**ADDENDUM NUMBER 3**

**PROJECT:** 46 KV Transmission Line – 2024 Modifications & Additions  
City of Fairhope (**BID NO. 25-003**)

**FROM:** Stewart Engineering, Inc.  
PO Box 2233  
Anniston, AL 36202  
(256) 237-0891

This addendum forms a part of the Contract Documents and modifies the original Construction Documents, Drawings and Specifications dated October, 2024 as noted below.

CITY OF FAIRHOPE	
46KV TRANSMISSION LINE - 2024	
MODIFICATIONS & ADDITIONS ALTERNATE #1	
DRAWN BY: ACG	DATE: 10-10-24
APPROVED BY: JLJ	DATE: 10-10-24
DWG#: AX23103-1	STEWART ENGINEERING ELECTRICAL CONSULTANTS ANNISTON, ALABAMA PHONE: (256)237-0891
SHEET: 7 OF 15	
SCALE: 1"=50'

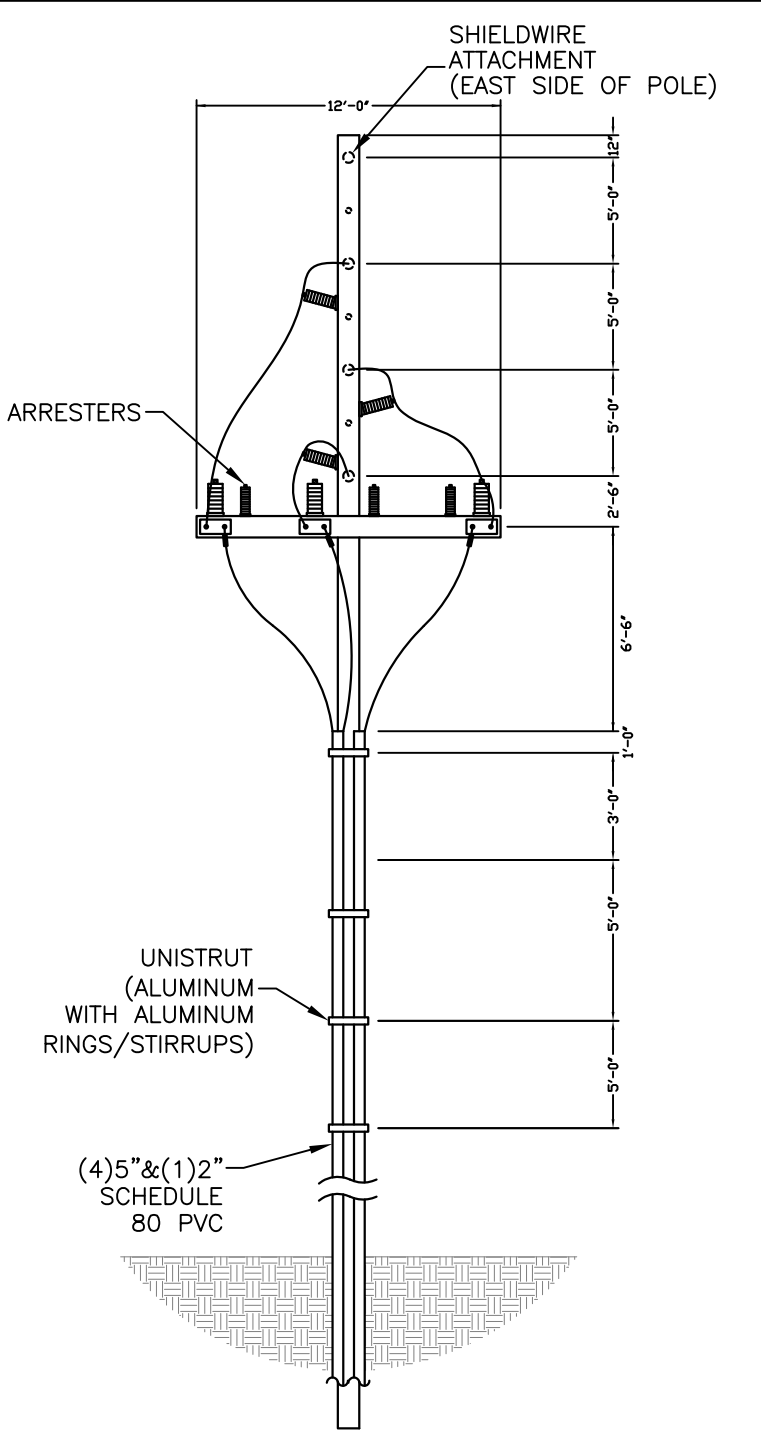
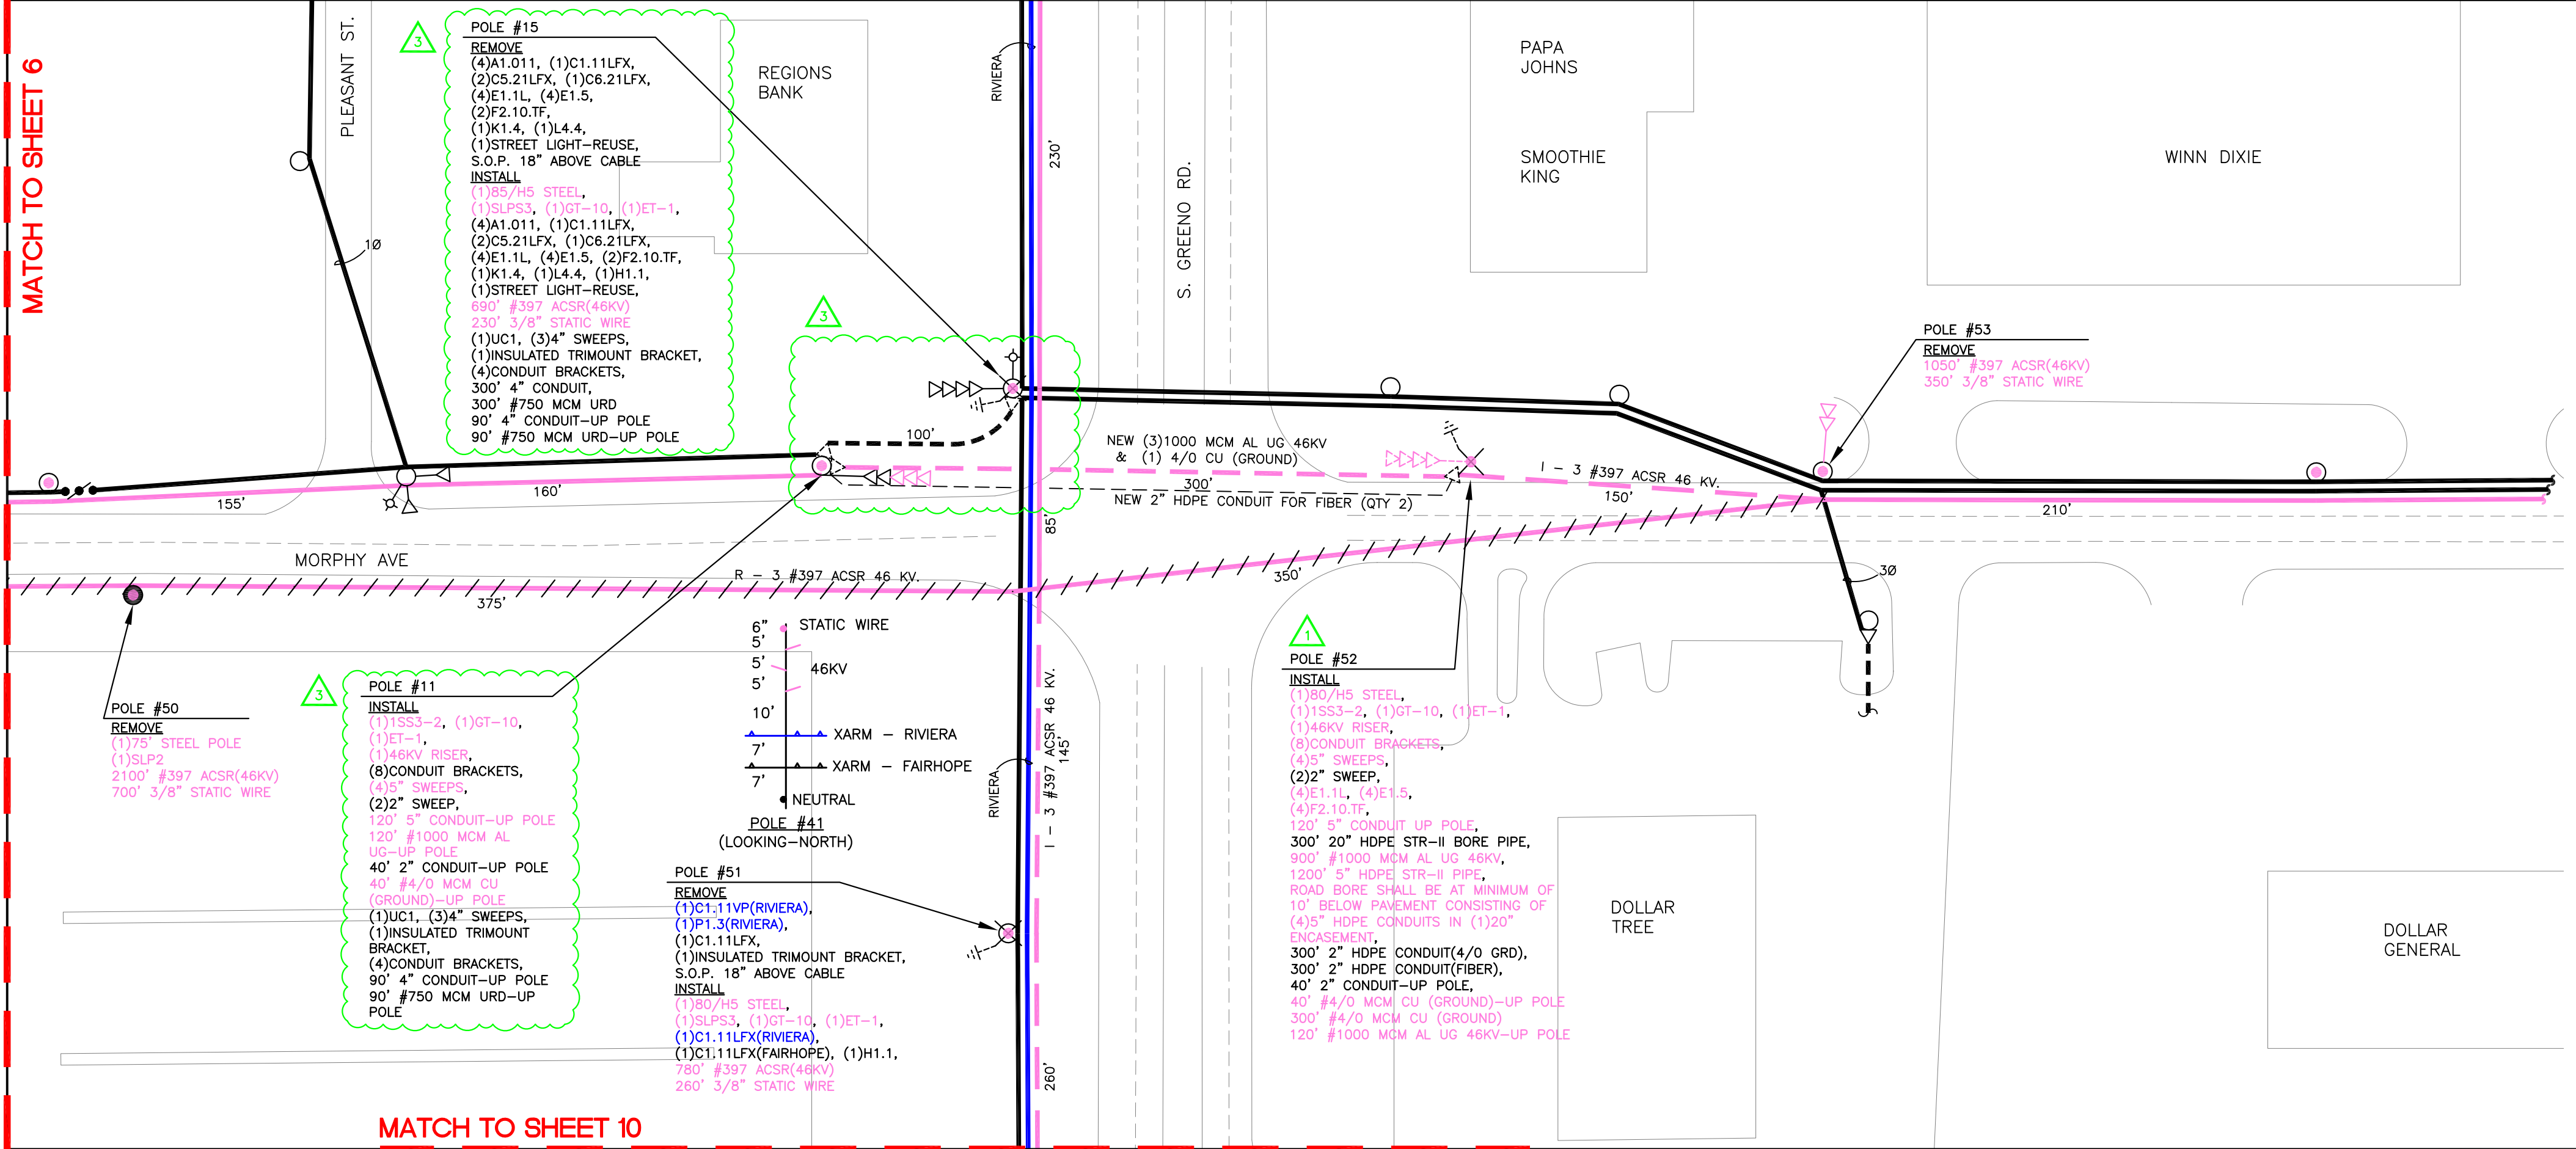
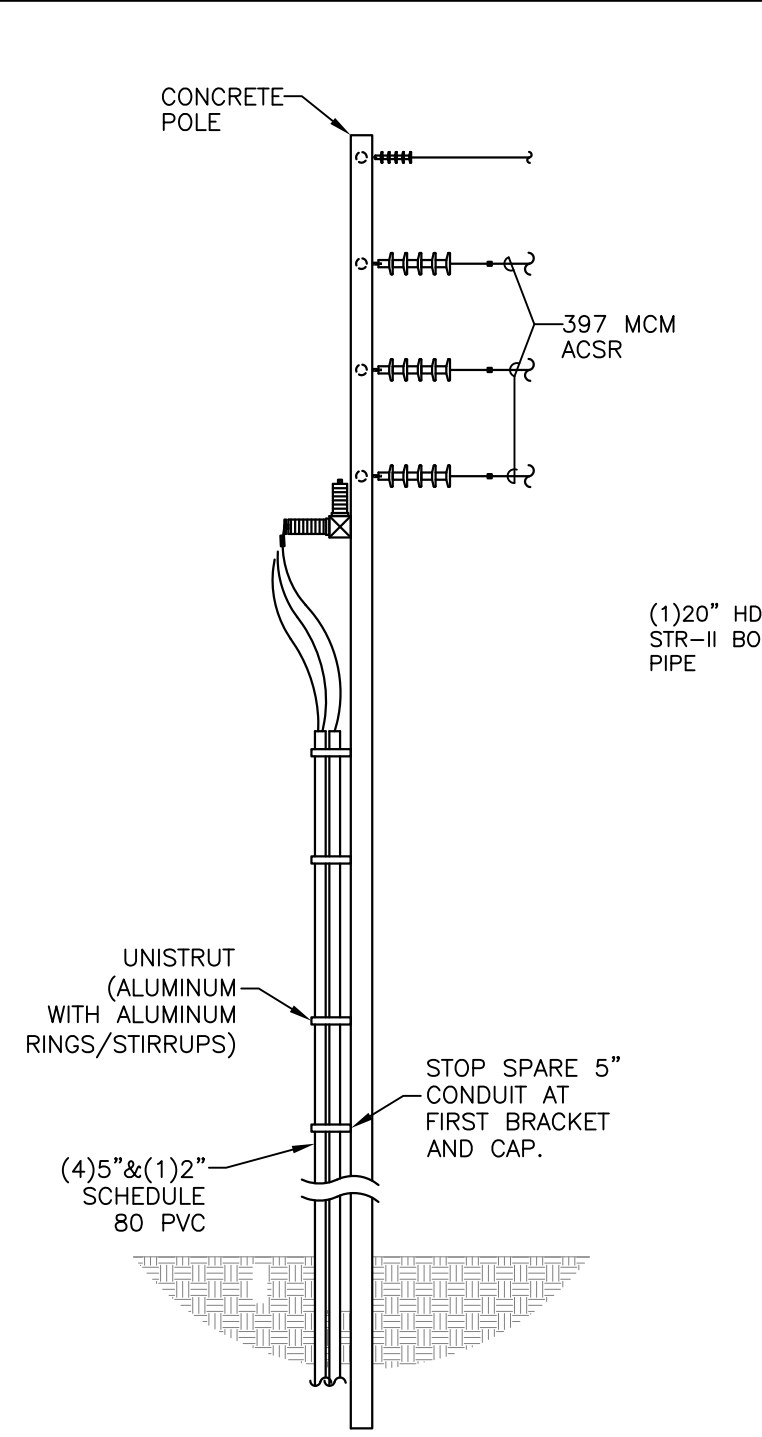
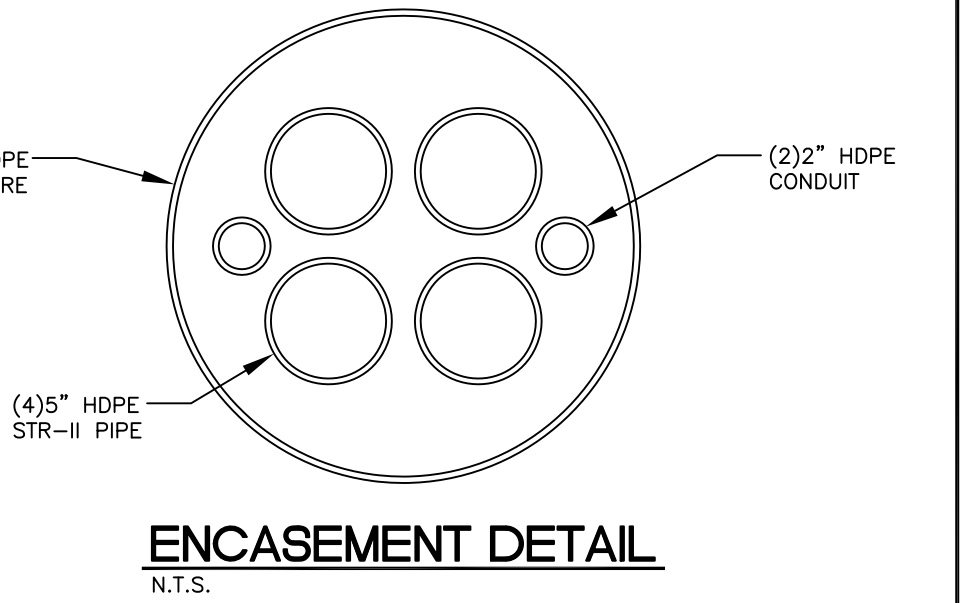
- 1 ADDENDUM #1 - 10-23-24  
REVISED TO REFLECT CHANGES  
ALONG MORPHY AVE. AND TO  
46KV VAULTS.
- 3 ADDENDUM #3 - 11-4-24  
REVISED TO REFLECT CHANGES  
ALONG MORPHY AVE. AND TO  
REMOVE 46KV VAULTS.

SCALE: 1/8"=1'-0"  
NOTE:  
GROUND WIRE ON THIS POLE  
SHALL BE 4/0 COPPER.
